Process Change Notification

PCN Number: PCN-2016-56 **PCN Notification Date:** 09/30/2016

STATS ChipPAC* Assembly, Test and Final Pack Site Transfer from Shanghai to Jiangyin CHINA

Below is a 2D representative image of the Package: MF (Mark Format) = 233 Rev A

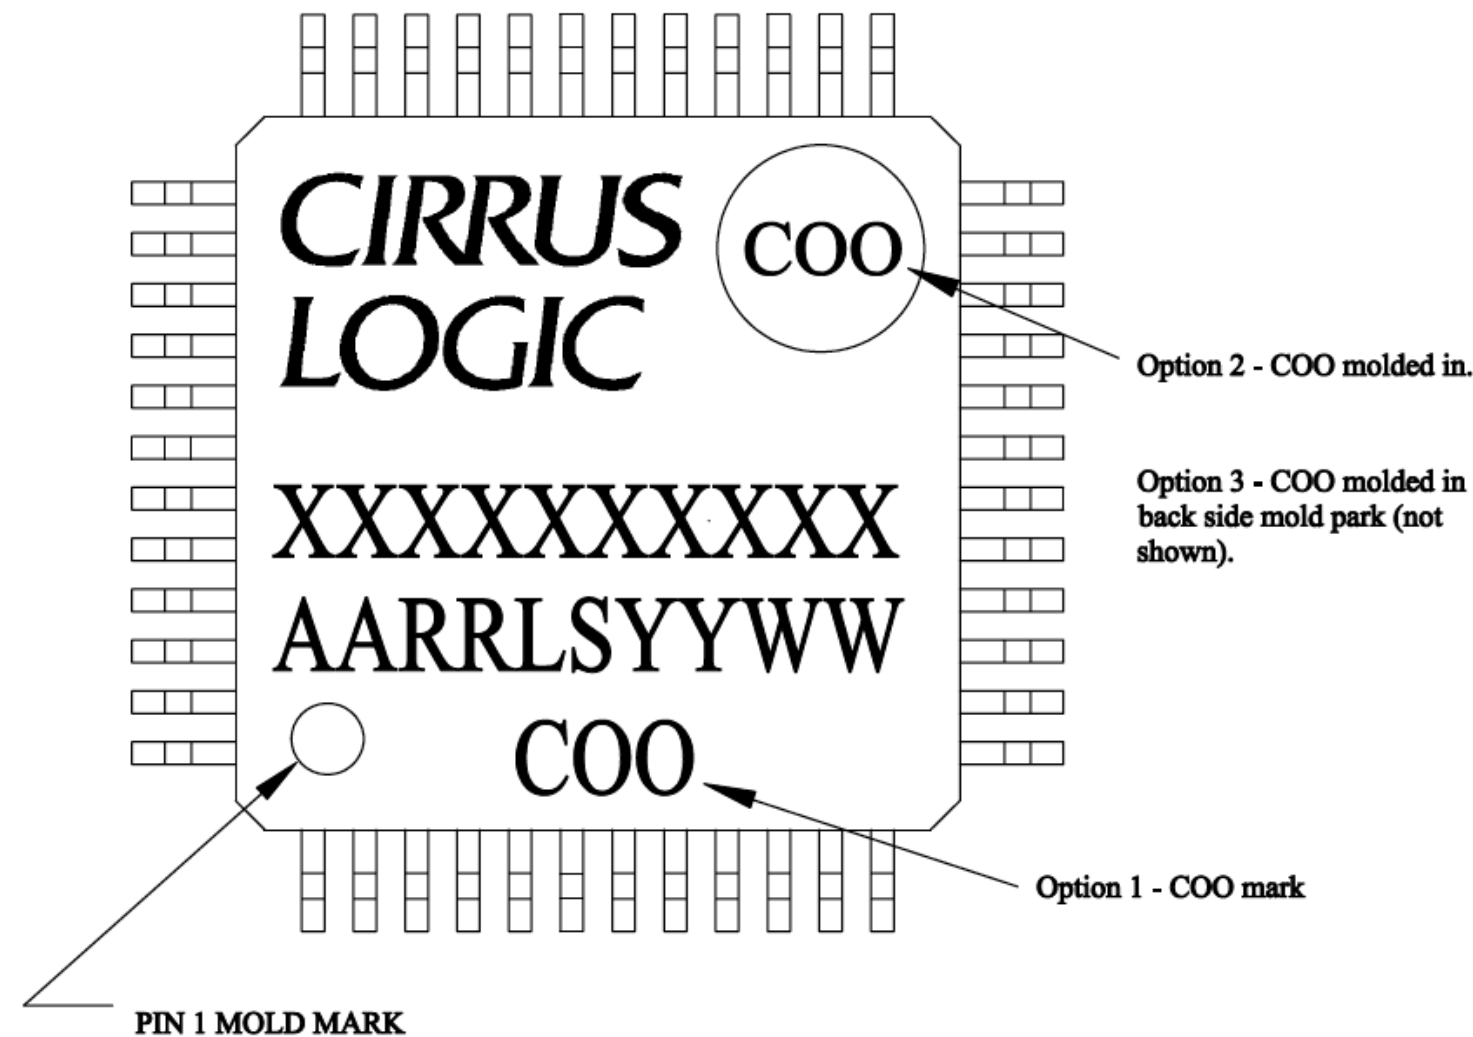
The Cirrus Logic component symbolization on the external face of the device reflects the designated Assembly Site location. The Assembly Site Code on the external face of the designated components will change. Specifically, the 1st two characters of the PackMark will change:

From: **"BA"**
To: **"BB"**
Note: All other symbolization will remain the same.

Mark Lay-out	Top Side Brand	STATS ChipPAC (Shanghai CHINA)	STATS ChipPAC (Jiangyin CHINA)	Comparison Results
See Below Illustration	**Logo Line**	CIRRUS	CIRRUS	Same
	1st Line: Cirrus Part Number	CS43xx[A]-CQZ[R]	CS43xx[A]-CQZ[R]	Same
	2nd Line: Package Mark	(**BA**RRLSYYWW**)** Site Code = AA Die Rev = RR LS = Lot Sequence Code YY = Year of Manufacture WW = Work Week of Manufacture	(**BB**RRLSYYWW**)** Site Code = AA Die Rev = RR LS = Lot Sequence Code YY = Year of Manufacture WW = Work Week of Manufacture	**Different**
	3rd Line: Country of Origin (COO)	CN	CN	Same
